# DESIGN REVIEW BOARD RECOMMENDATION MTG

## TROY LAUNDRY / BOREN INVESTMENT BLOCK

DPD PROJECT #3012675  
06.26.2013

## COMMENT #1: MASSING

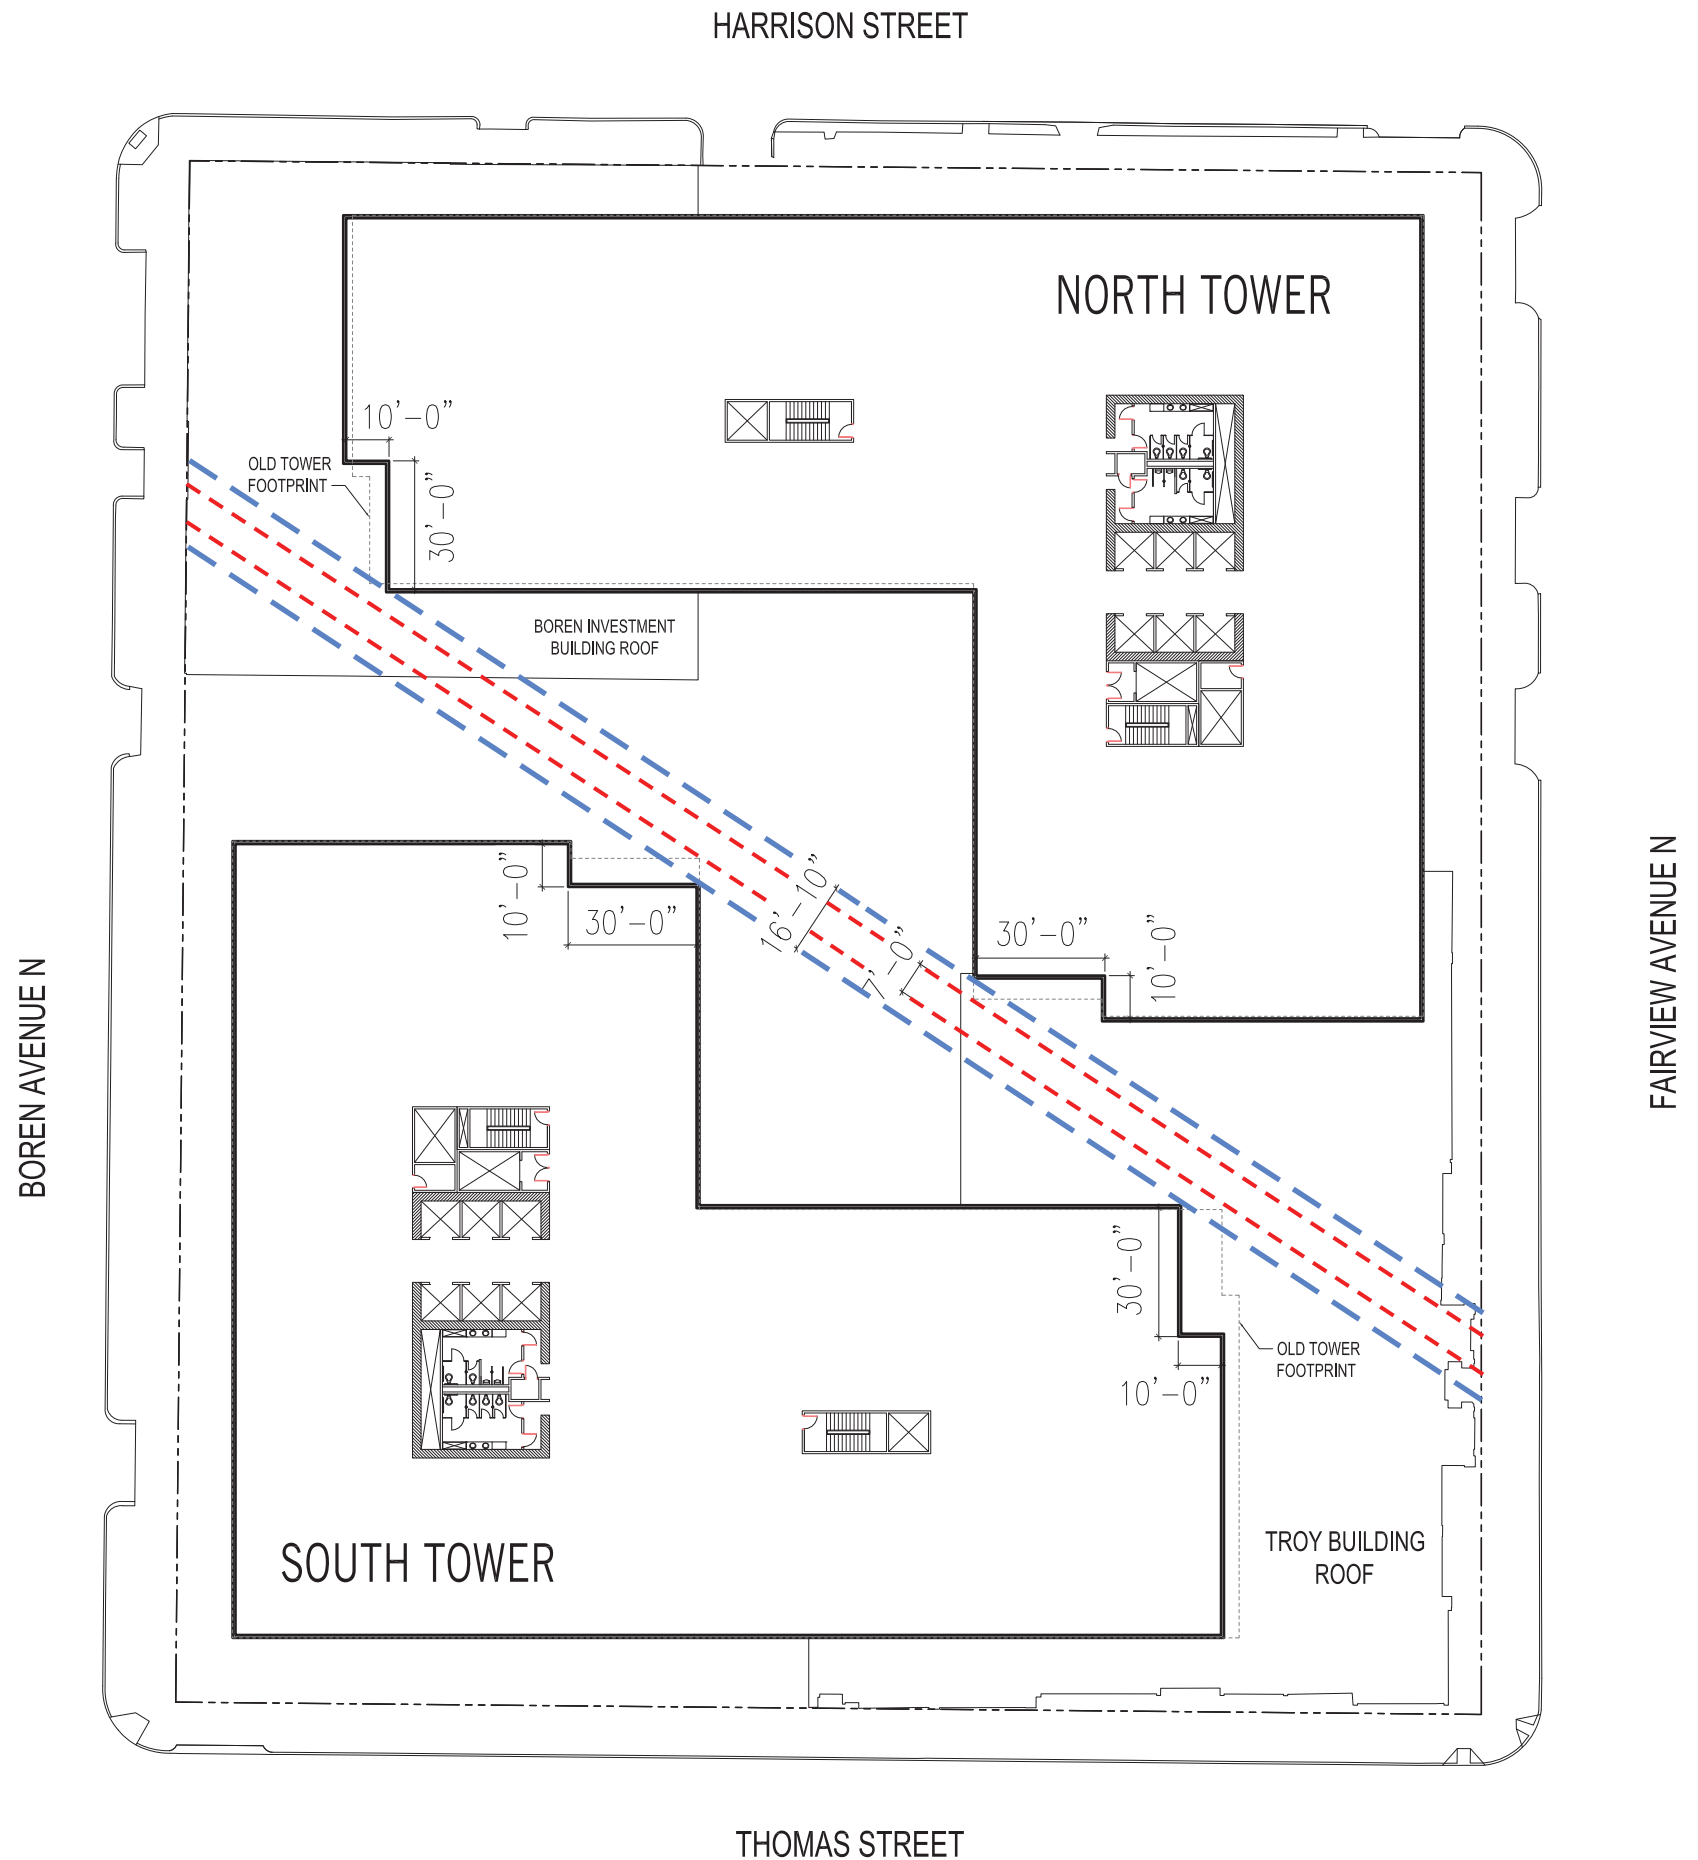
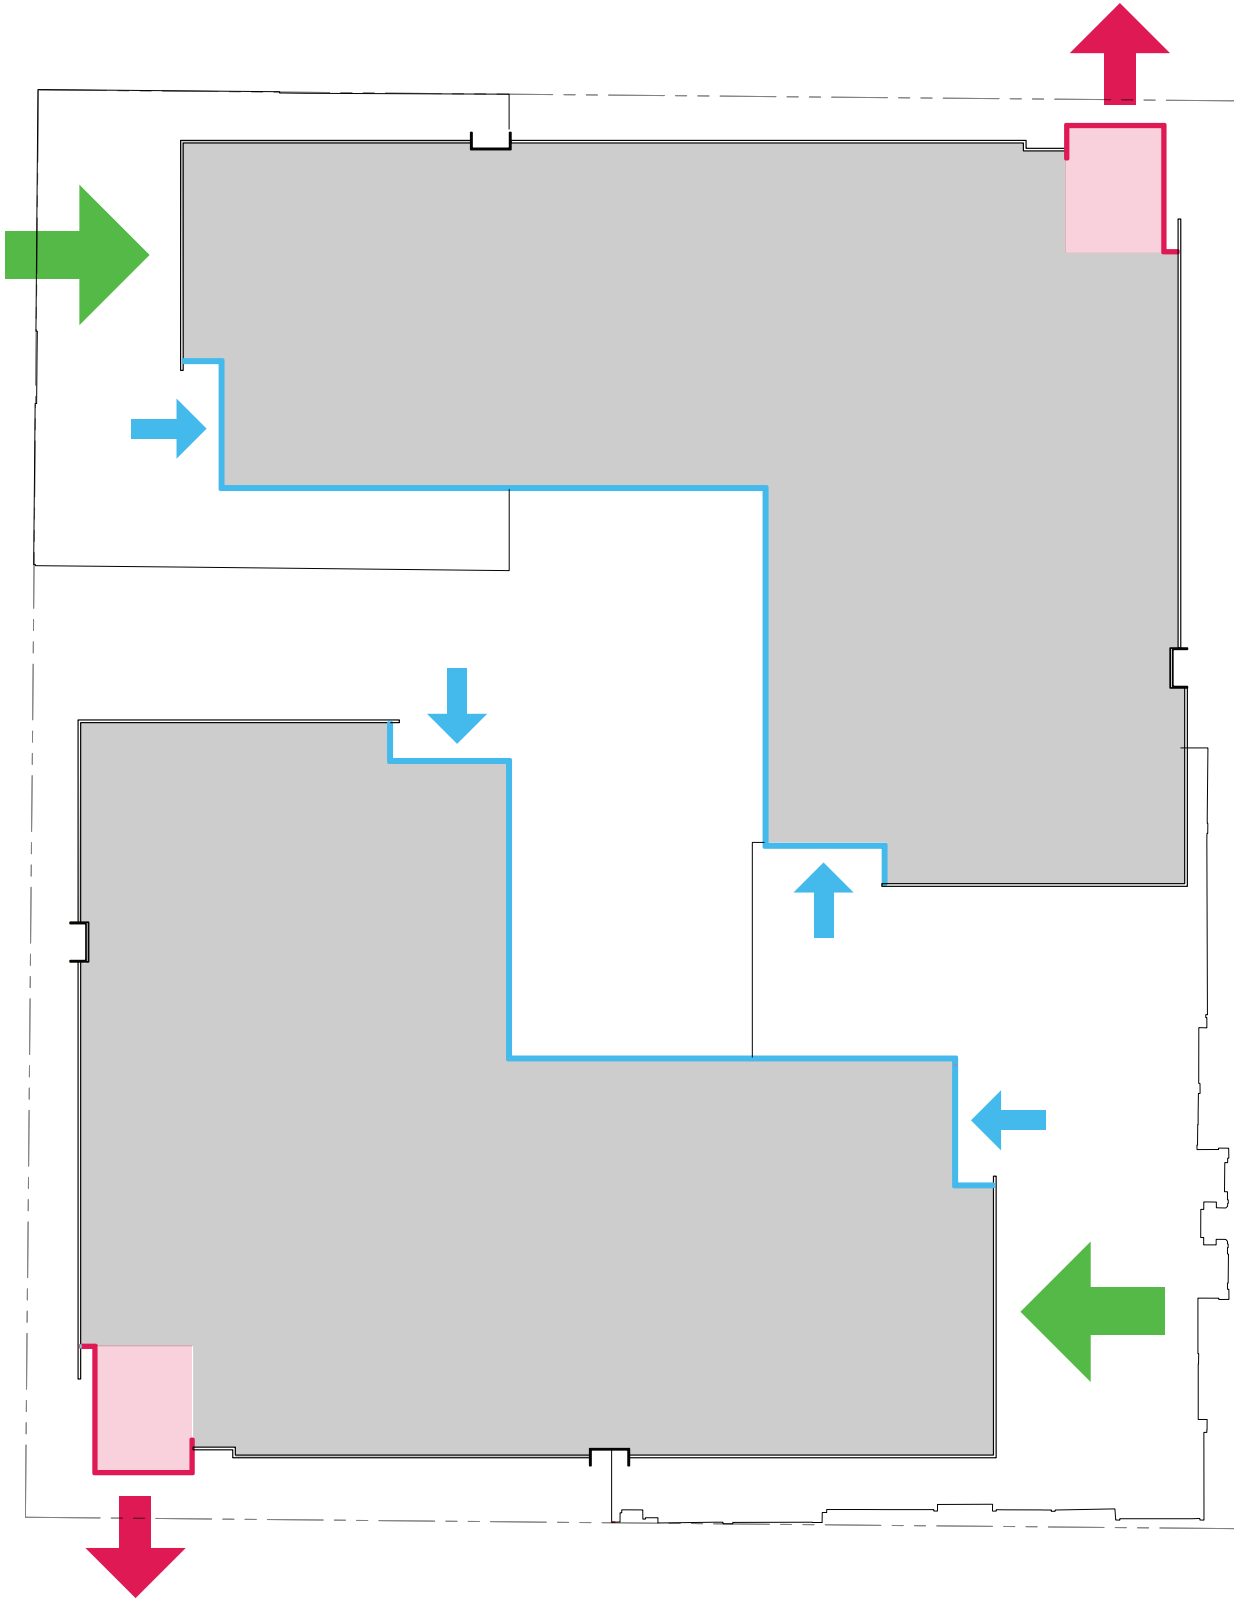
1. **Massing:** The massing and design response indicates a full block building that holds a continuous horizontal line at the floor plates and roofline, with a consistent architectural expression including minimal modulation and articulation. The Board noted that the proposed design does not appear to respond sufficiently to the EDG. (A-1, A-2, A-4, B-1, C-1, C-2, C-3, C-4)

a. The view through the courtyard doesn't provide the **visual separation** as directed by the Board at the Second EDG meeting. The internal corners should be set back further or chamfered to increase the appearance of separation between the buildings. The Board noted that the glazing and stepped back façade at the internal corners is a positive direction, but the massing and treatment doesn't provide a sufficient response to EDG. (A-1, A-2, A-4, B-1, C-1, C-2, C-3)

The corners of both buildings at the courtyard have been pushed back to 10'-0" and widened to 30'-0", which increased the separation from 7'-0" to 16'-10". This move also gives modulation to the ends of the buildings.

## FAIRVIEW AVENUE

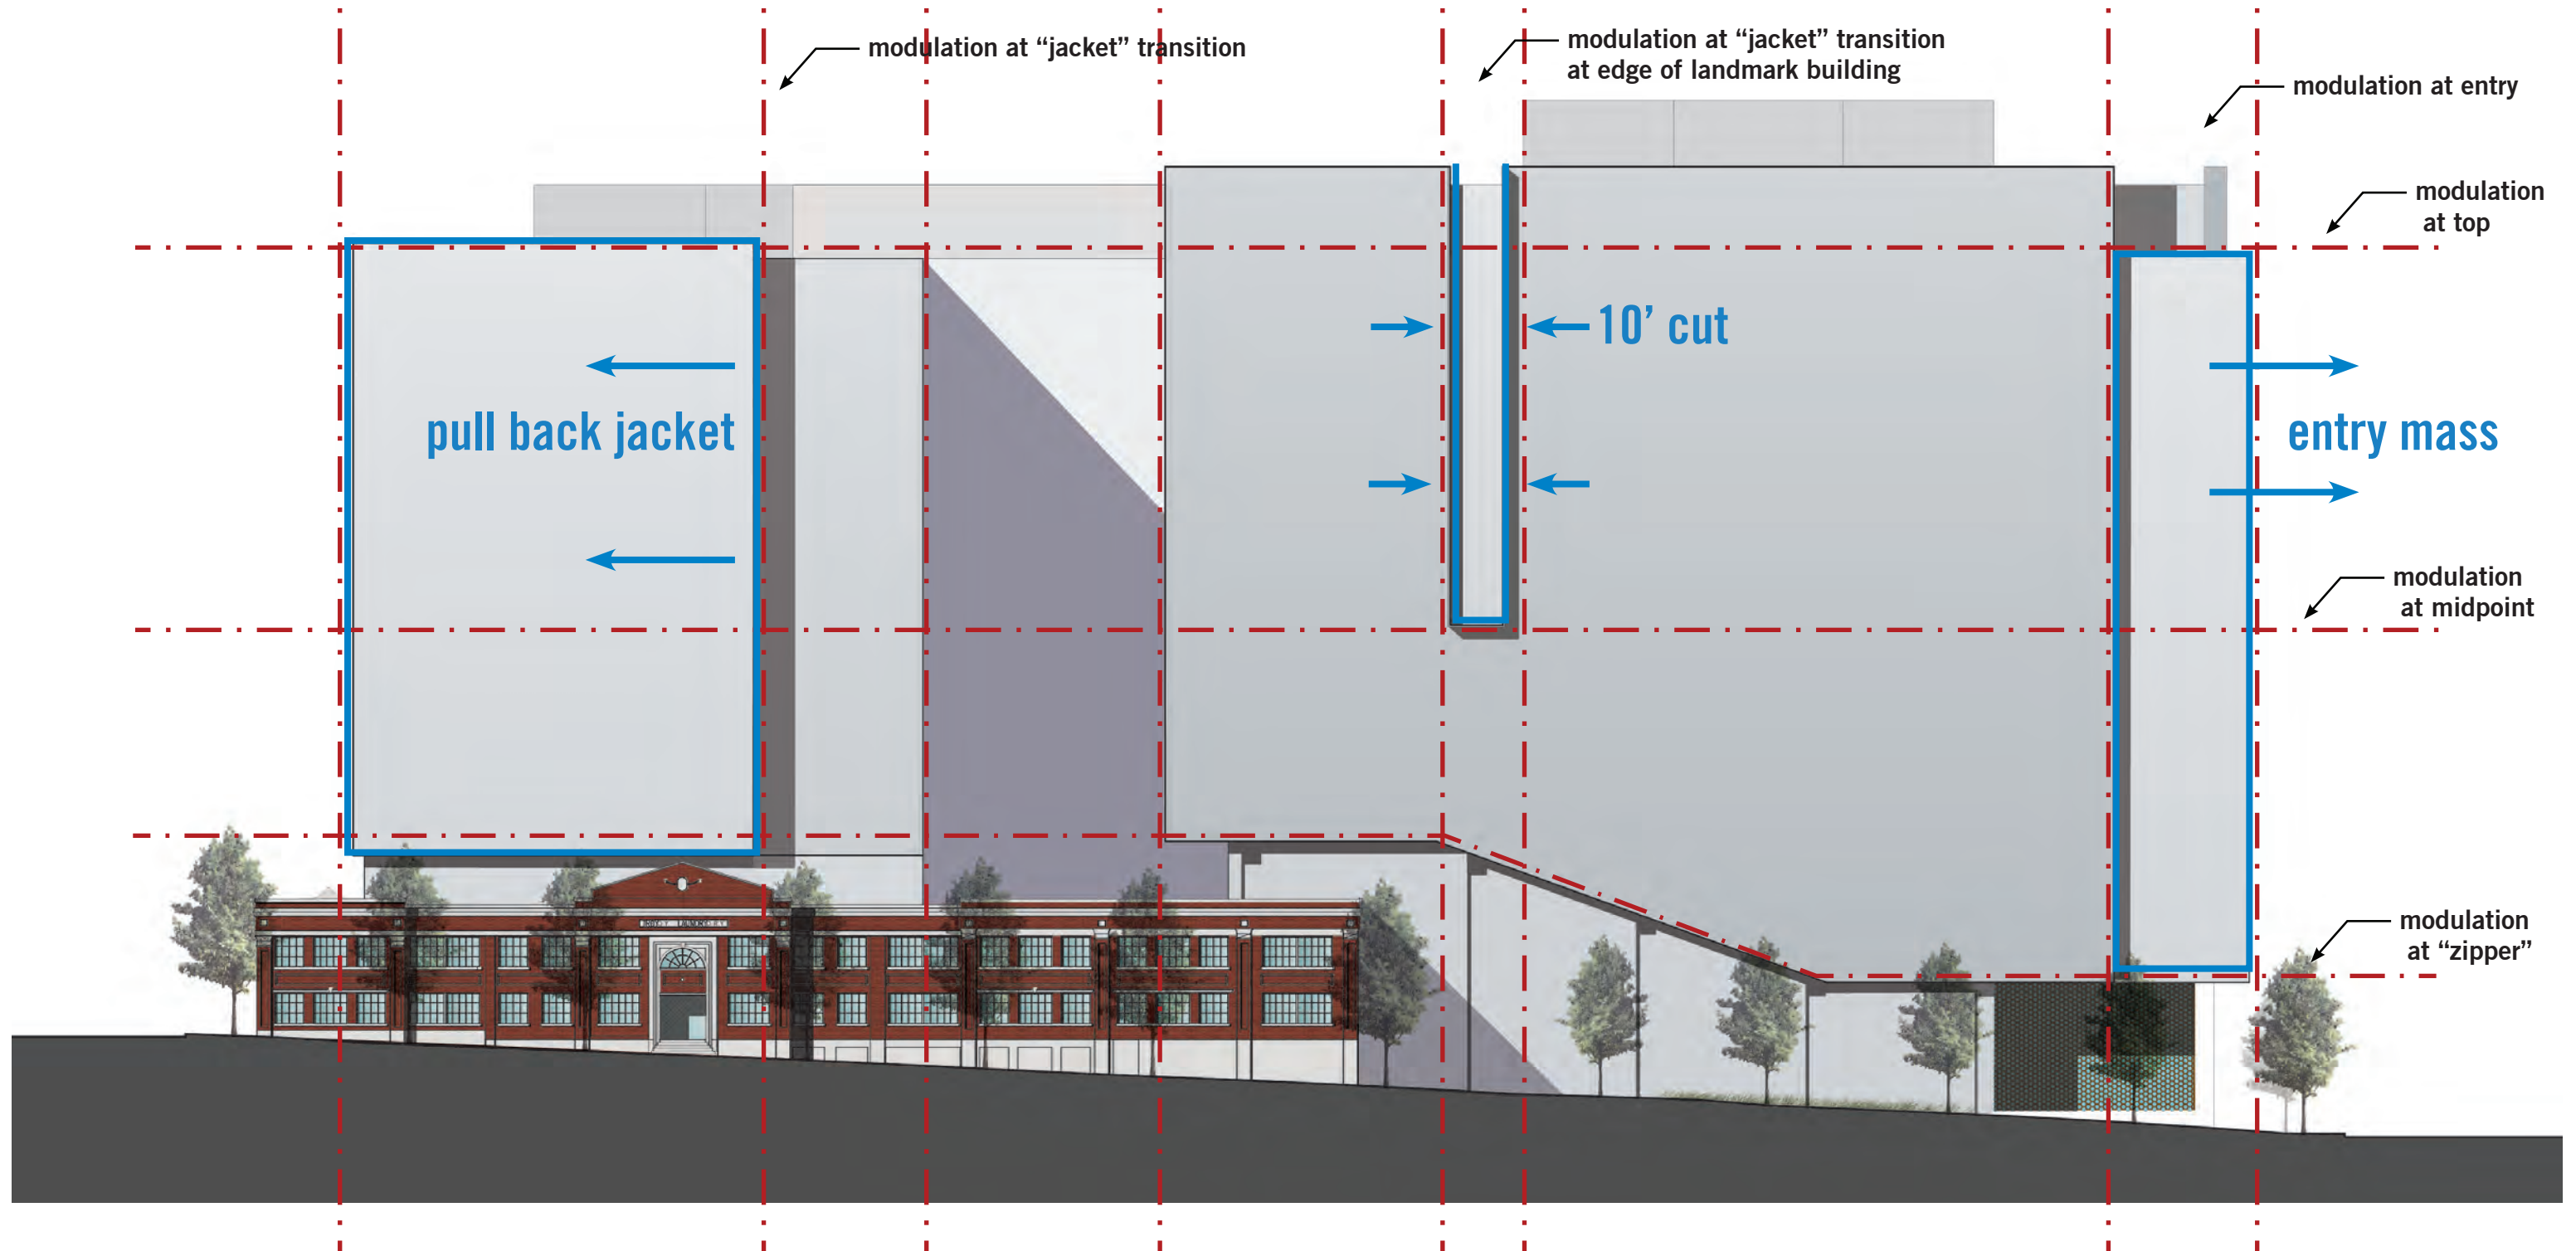
d. The applicant should provide studies showing **alternate design techniques** and **massing changes** to reduce the scale of the north, east, and south facades. Possible treatments include **texture, modulation, color, material change, interrupting the continuous horizontal banding**. The Board noted that the solutions should respond to the design parti and concept, but should result in a reduction of scale to the north, east and west facades. (A-2, A-3, B-1, C-1, C-2, C-3, C-4)

**RESPONSE:** We have located the places for modulation that work with the design parti.
